FED. RD. DIV. NO.	PROJECT NO.	SHEET NO.
6		1
STATE	STATE DIST.	COUNTY
TEXAS	SAT	GUADALUPE
CONT.	SECT.	JOB HIGHWAY NO.
0915	46	052 CORDOVA

30% SUBMITTAL

FEDERAL AID PROJECT
 PROJECT NO.
 CSJ: 0915-46-052
 LIMITS FROM: SH 46
 TO: SH 123

FOR WORK CONSISTING OF EXPANDING ROADWAY FROM 2 TO 4 LANES WITH RAISED MEDIAN OR CENTER TURN LANE. REALIGN CORDOVA ROAD AT SH 46. ADD SHARED USE PATHS.

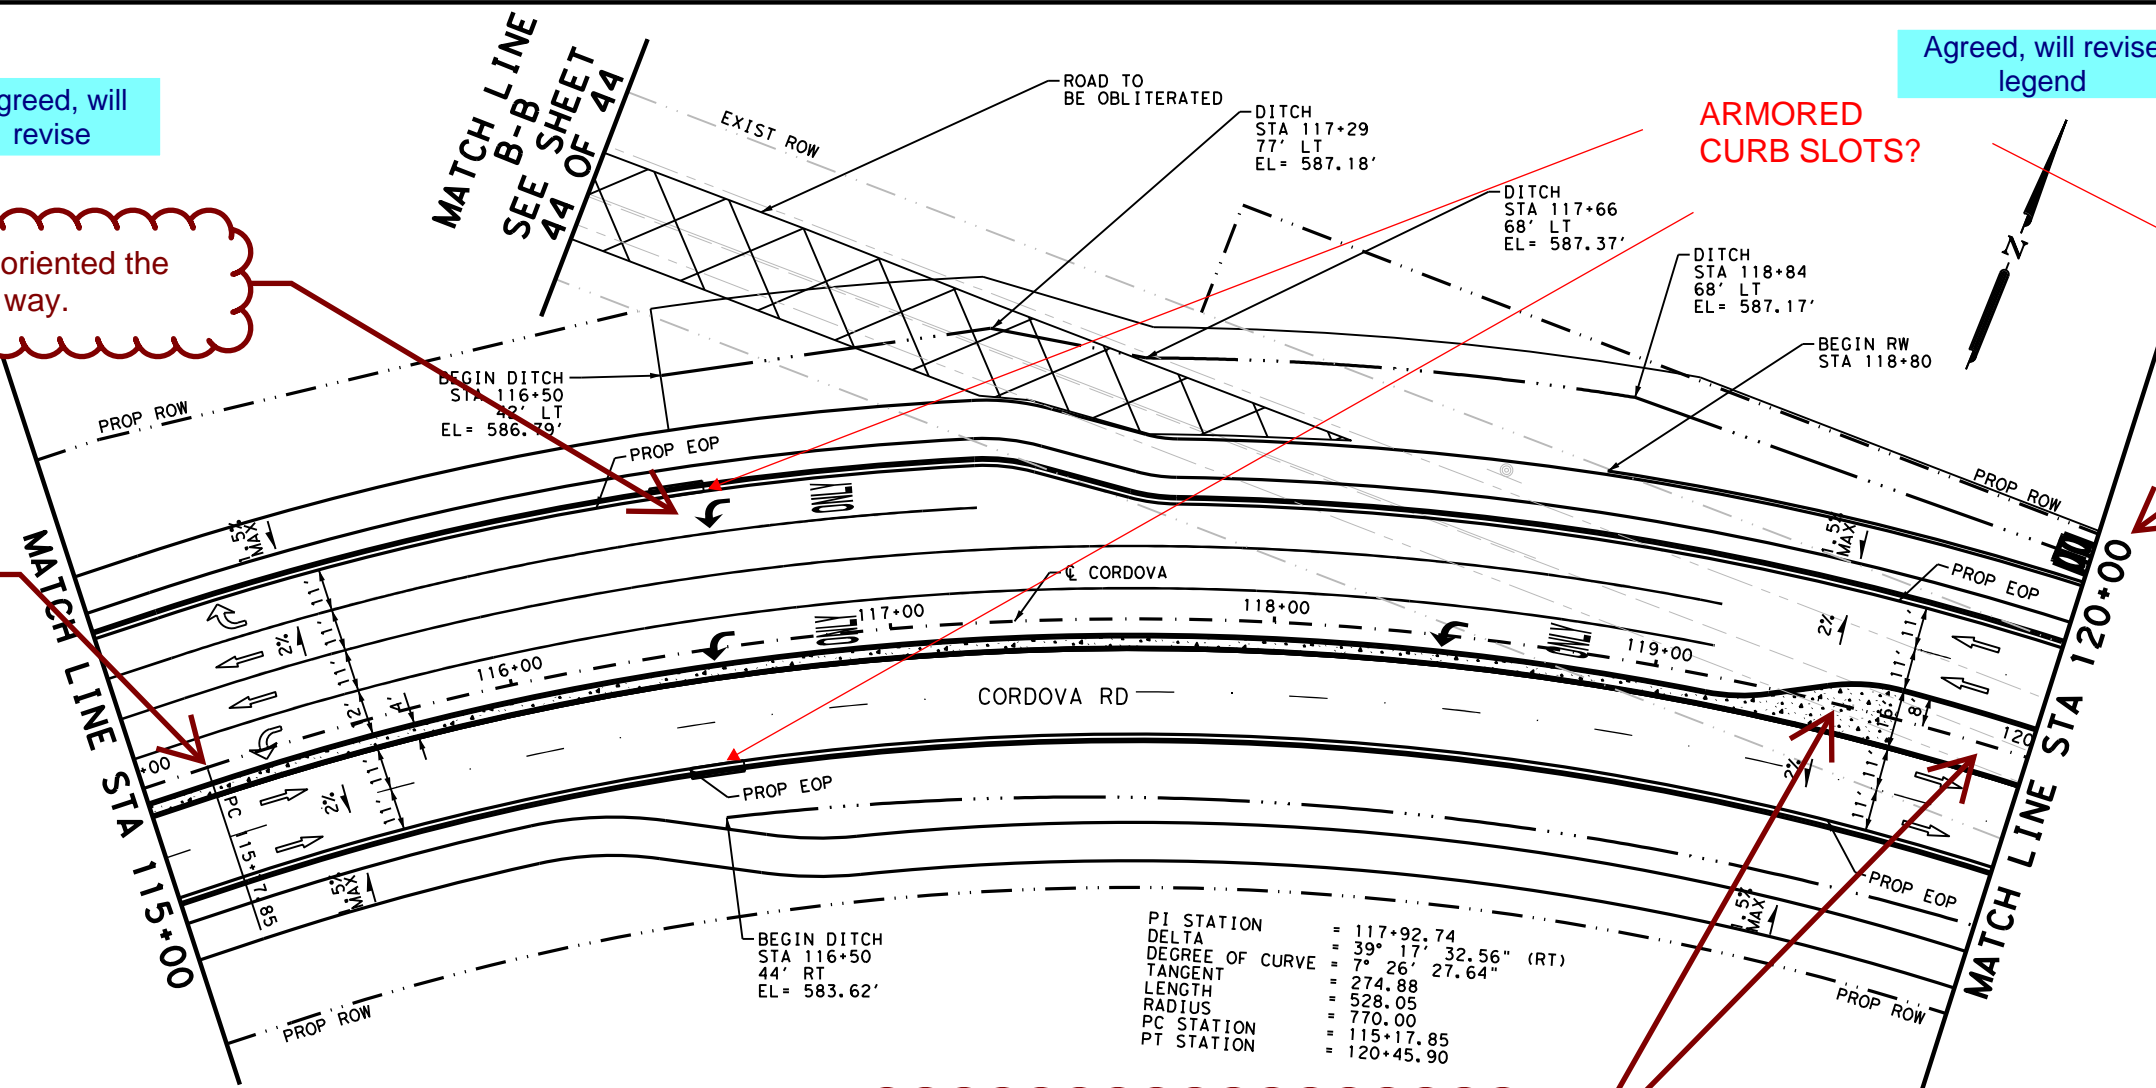
Arrow oriented the wrong way.

FOR ALL:
Show PC and PT Stations w/ a little larger text size

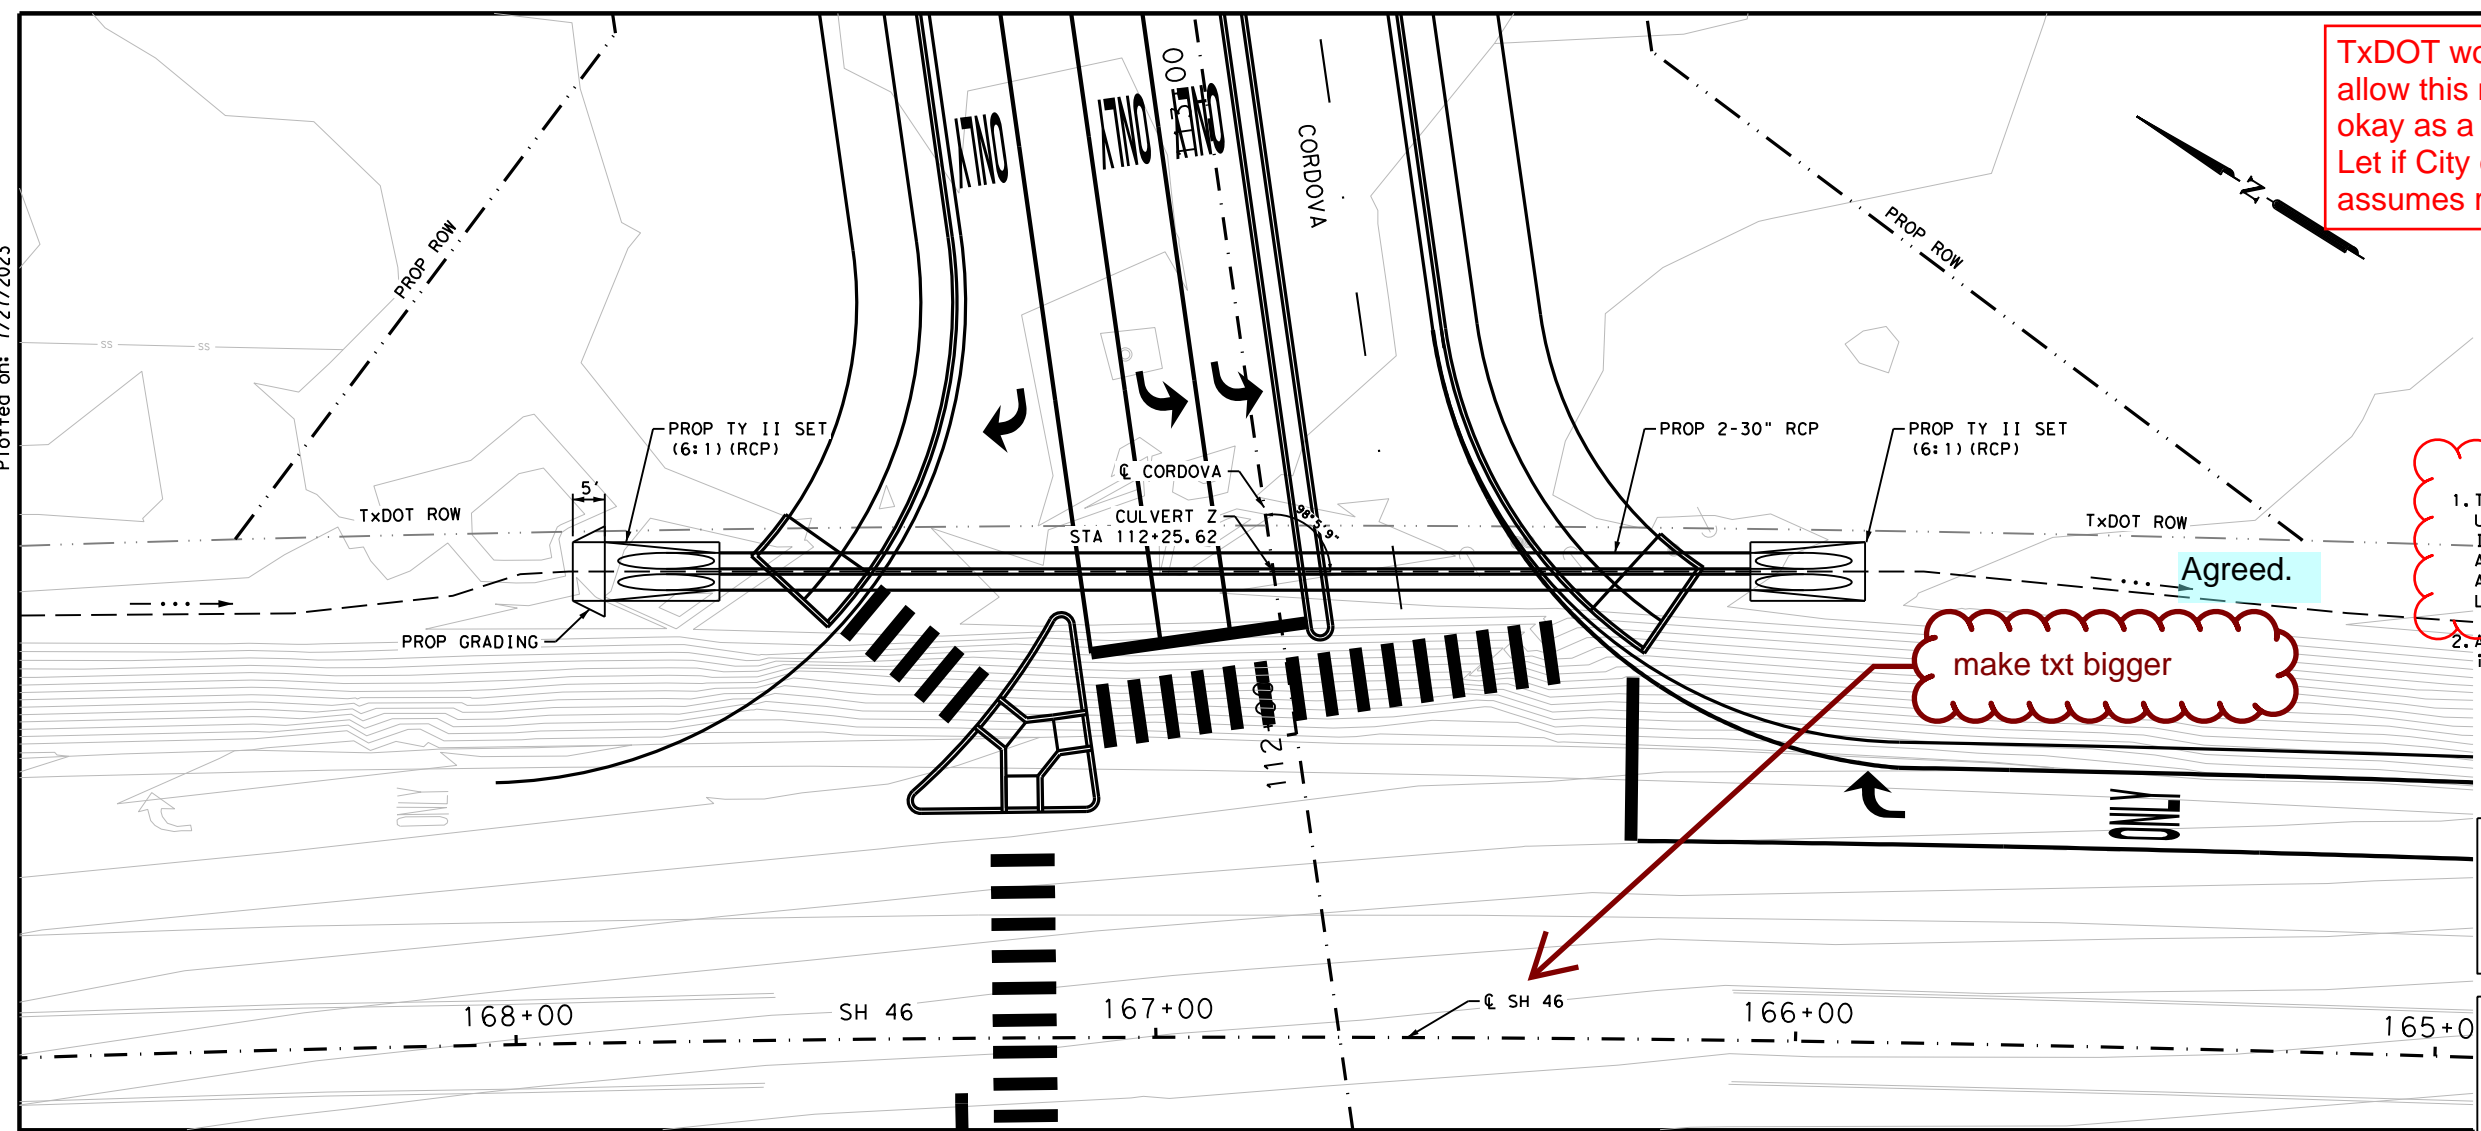
TxDOT would not allow this note. Is it okay as a Local Govt Let if City of Seguin assumes risk?

Note changed.
